ITEM 51
MANAGER'S REPORT NO. 43
COUNCIL MEETING June 10/74

Re: Letter dated May 15, 1974 from Mr. D.L. MacKay
Chief Engineer, Greater Vancouver Sewerage & Drainage District
Requesting reconsideration of a Decision to Not Approve of
Piping North Branch of Still Creek - Boundary to Lougheed

TO: MUNICIPAL MANAGER
FROM: PLANNING DIRECTOR
SUBJECT: STILL CREEK NORTH BRANCH BETWEEN
BOUNDARY ROAD AND LOUGHEED HIGHWAY

SUBJECT: PROPOSAL TO PIPE NORTH BRANCH OF STILL CREEK
BETWEEN LOUGHEED HIGHWAY AND BOUNDARY ROAD

Portion of North Branch
 proposed to be enclosed.

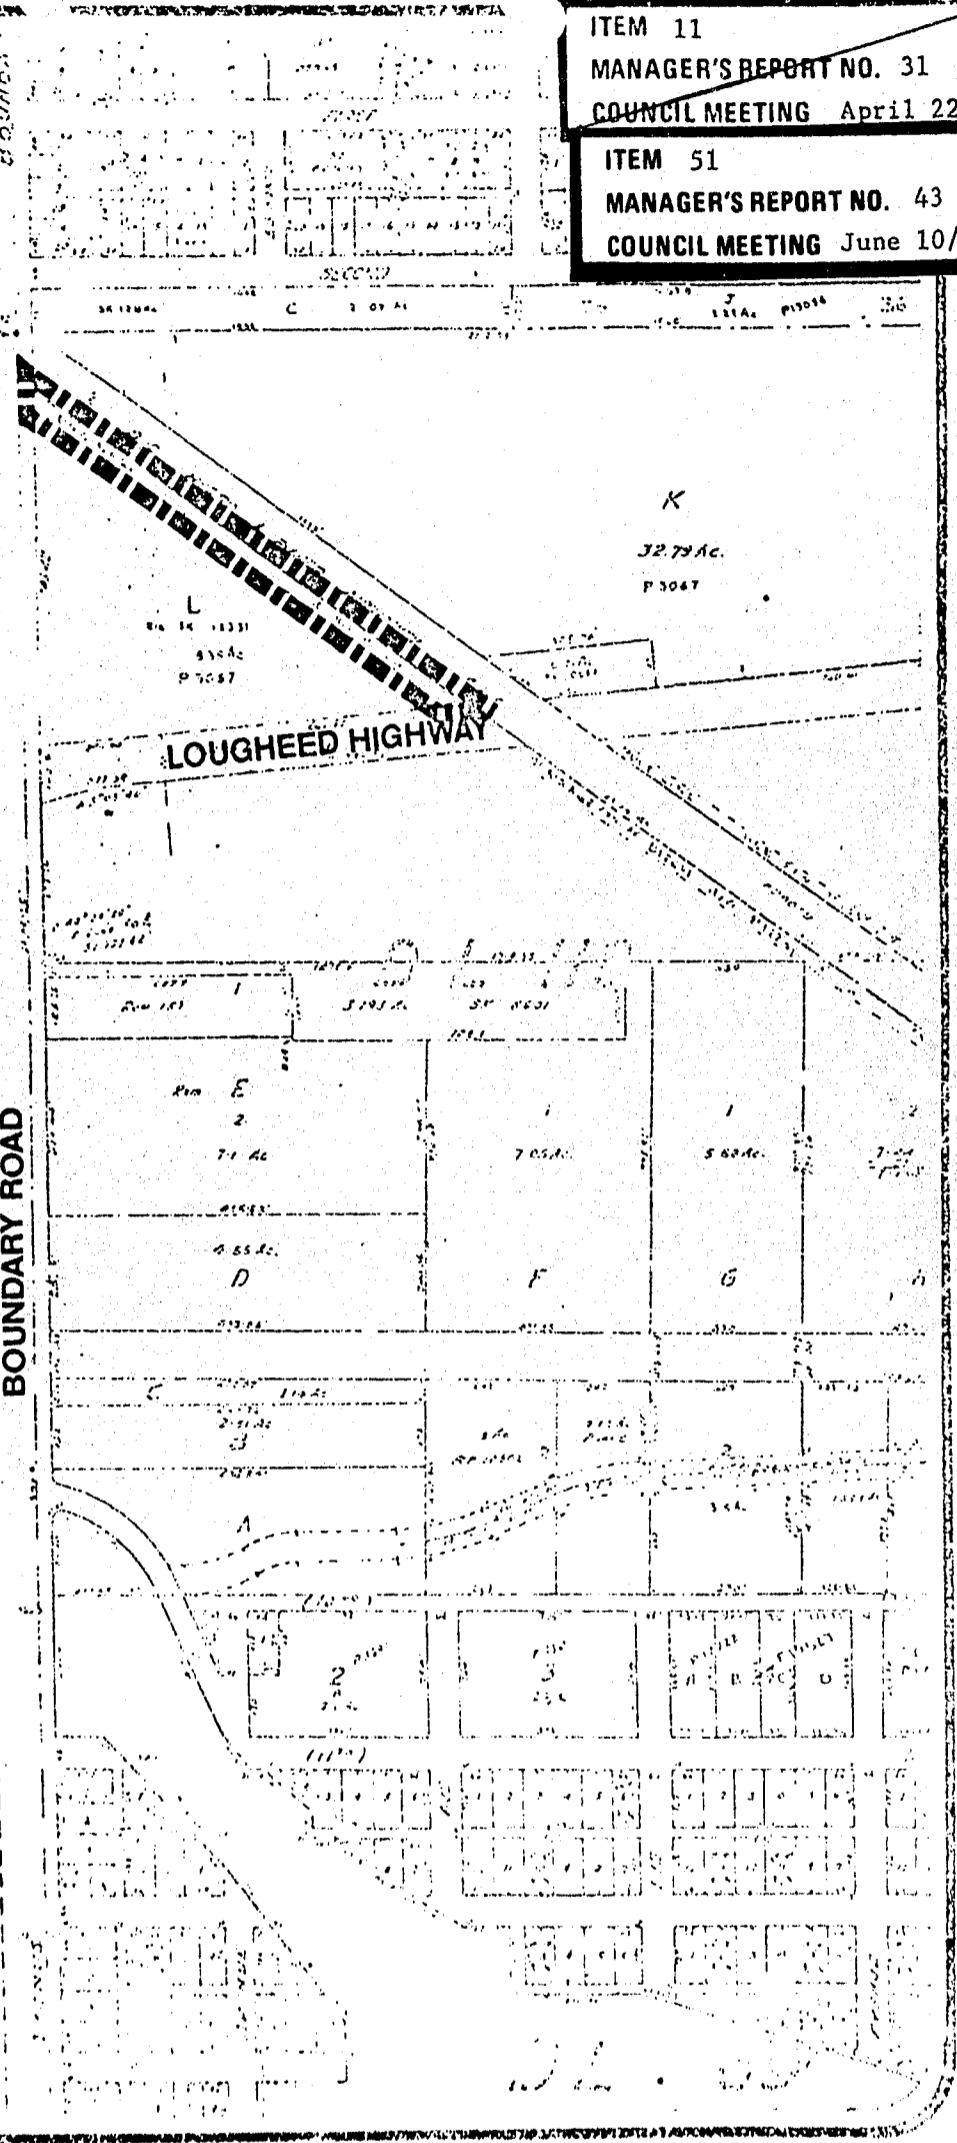
This waterway is known as the North Branch of the Still Creek system, originating in the north-east sector of Vancouver and flowing south-eastward to join the main stream of Still Creek just east of Gilmore Avenue. This stream exists at present as an open waterway through its course in Burnaby, and flows entirely through industrially zoned lands. The attached sketch indicates the portion under examination at this time.

However, the Department of Environmental Health advises that the water quality of this particular stream has been poor and that preservation of the stream in an open condition is preferred from an environmental point of view for a variety of reasons. Maintenance of the open waterway on easement permits immediate visual inspection of the water quality, proper opportunity for sampling check points, and provides for immediate and direct corrective operations in the event of spills or other contamination upstream. Moreover, there

is a certain benefit from biological action (aeration, sunlight, etc.) in the open stream which would not be present in a piped waterway, a consideration which is significant in this particular case.

The results of these studies will provide Council with the information necessary to establish clear policies on the piping or retention of specific open watercourses. In the case of the stream under present consideration, it is apparent that there are important reasons related to pollution and control why the watercourse should not be enclosed at this time.

- 1) the earlier resolutions of Council (April 22, 1974) concerning this matter be rescinded, and
- 2) the Council agree to the enclosure of that portion of the North Branch of Still Creek lying between Boundary Road and the Lougheed Highway subject to:
 - a) the provision of suitable access and inspection chambers,
 - b) the identification of all present outfalls into the stream course in this section, and
 - c) a statement of all intended discharges into the waterway in this section,all of the above to the satisfaction of the Chief Public Health Inspector, and
- 3) a copy of this report be sent to Mr. D. L. MacKay, Chief Engineer for the Greater Vancouver Sewerage and Drainage District and to B.C. Hydro and Power Authority.
